To: City of Scottsdale

Summary of Modifications

Civil and Landscape Drawings

Architectural Elevations and Building Design

(South) REAR ELEVATION 1/4" = 1'-0" B

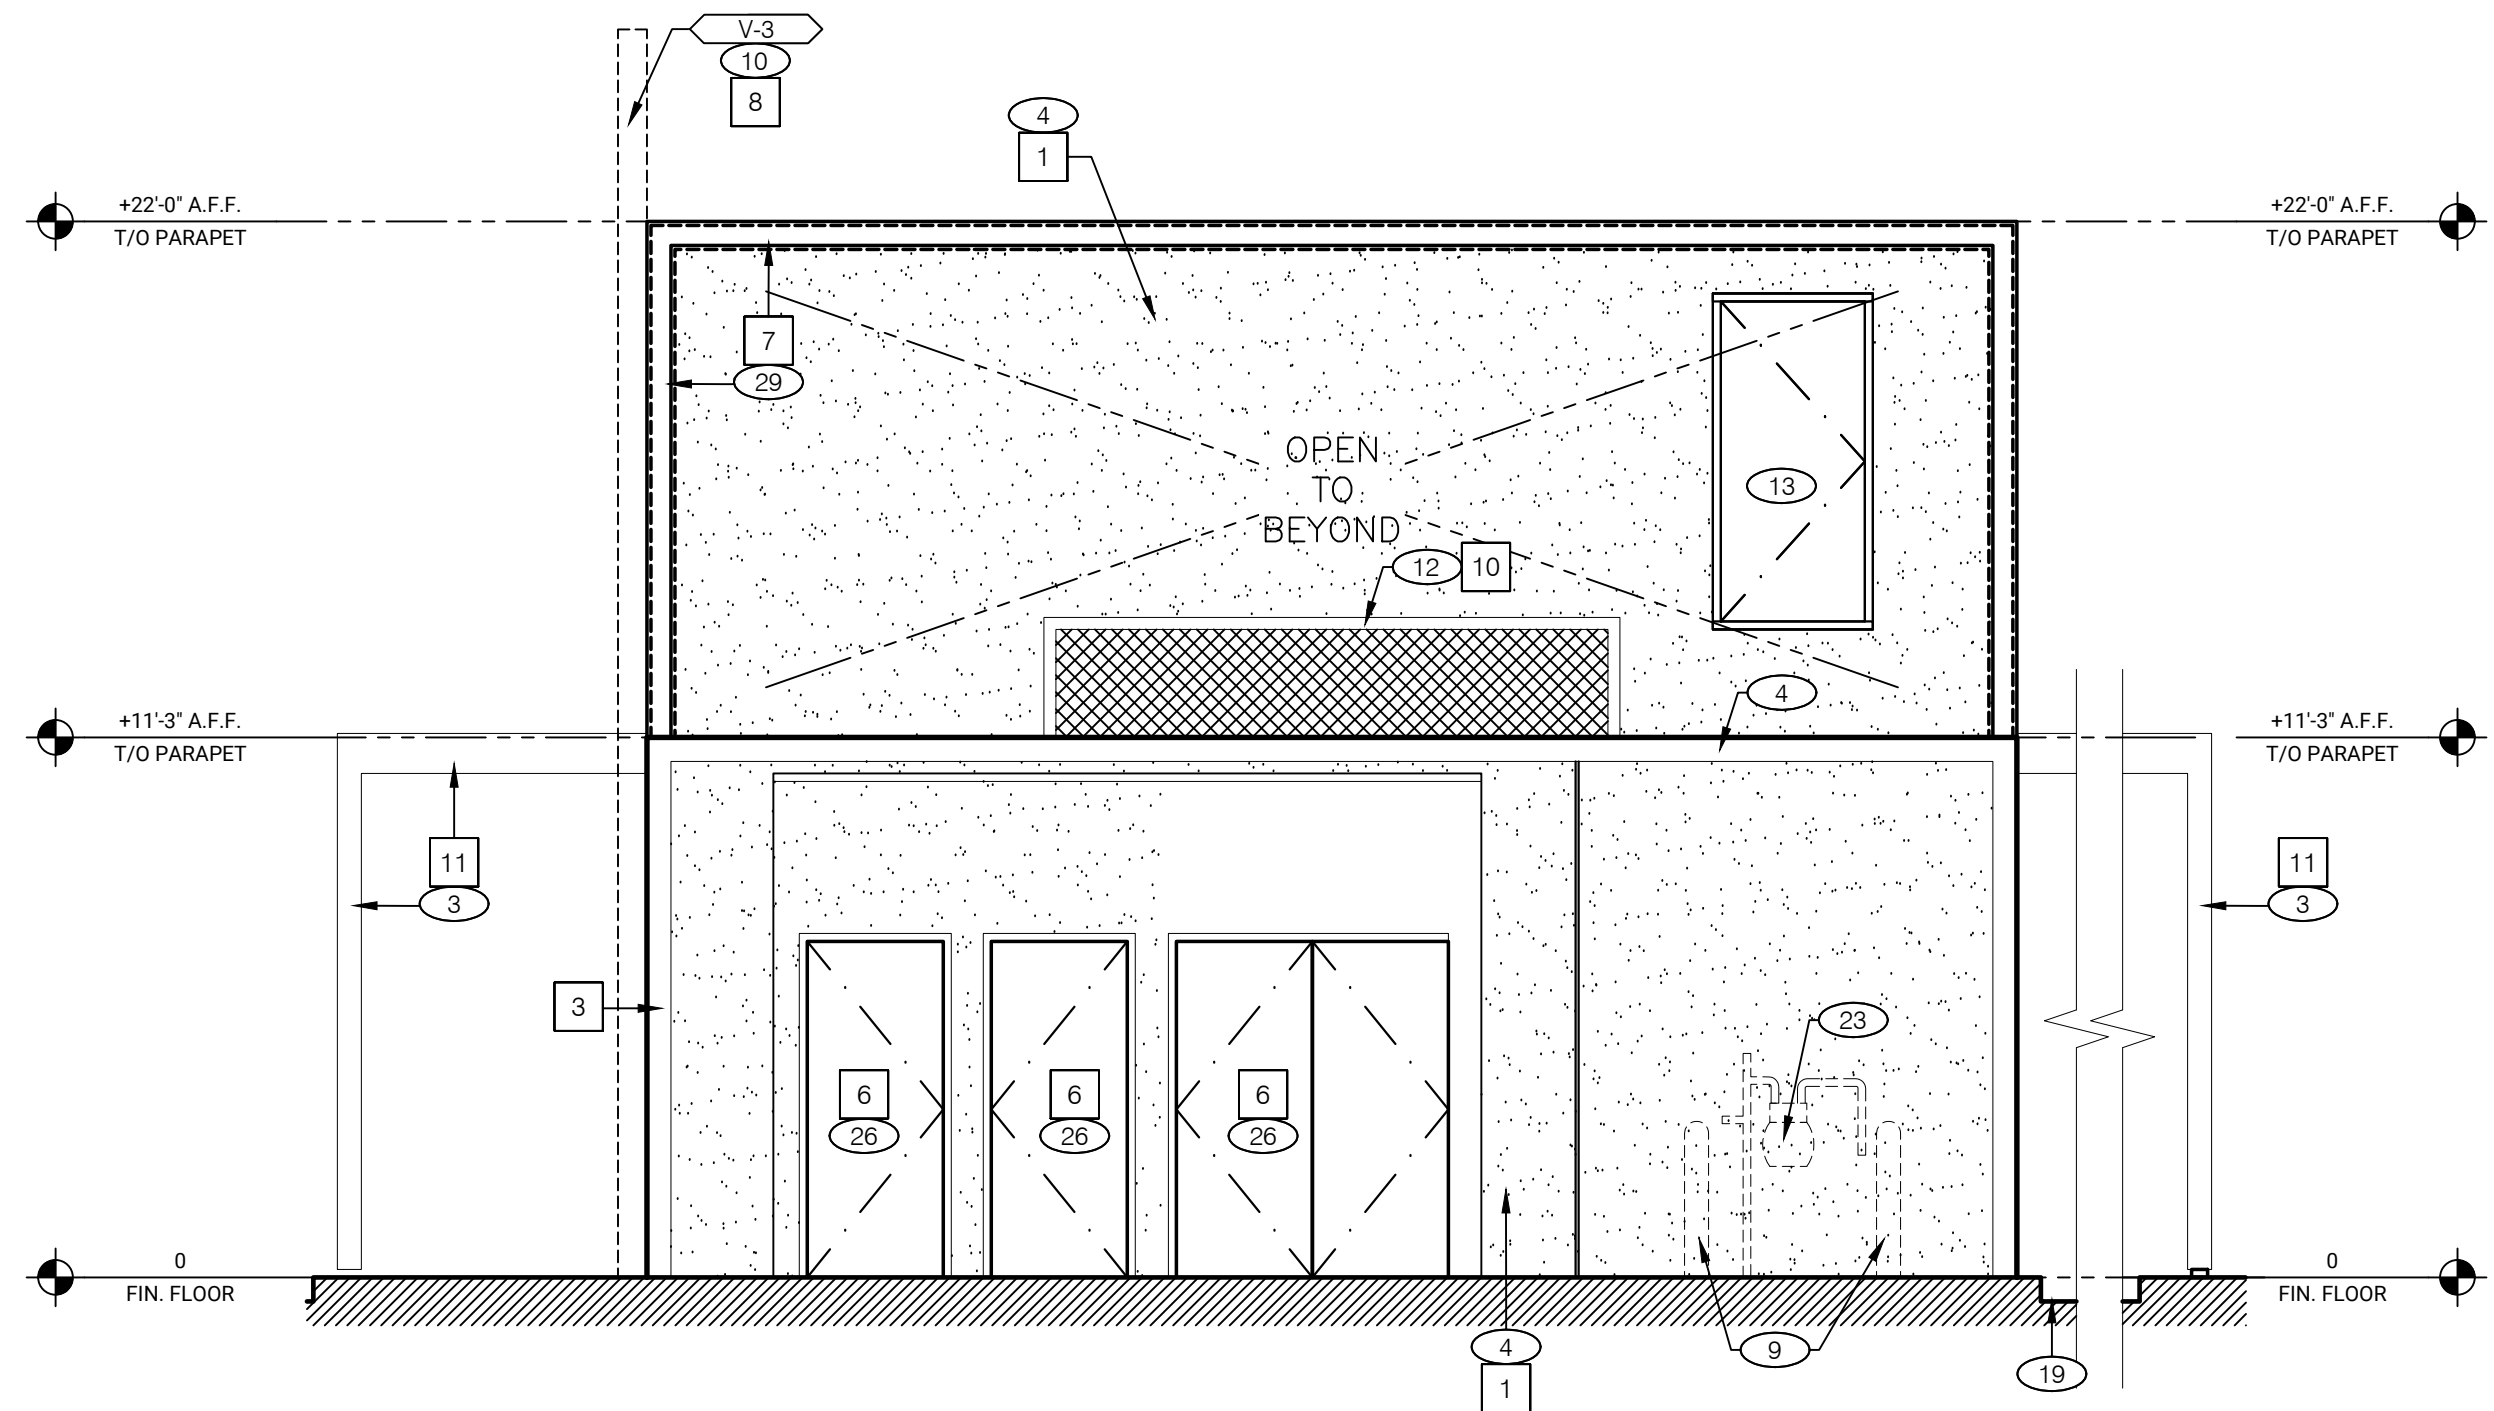
- Revised elevation labels per comments.
- Included rendering of all elevations.
- Clarified detailing of the patio and railing.
- Enclosed all meters on rear of building.
- Provided detailing on door/windows wall recesses.
- Revised all finishes on building.
- Included a mural on building.
- Provided vertical louvers at primary tower element.
- Removed signage from portal “tombstone” at primary entrance.
- Extended front canopy to connect to building at banding.
- Added roof and floor plans.
- Clarified canopies on all three primary sides of building, connected to building mass, as integral elements.
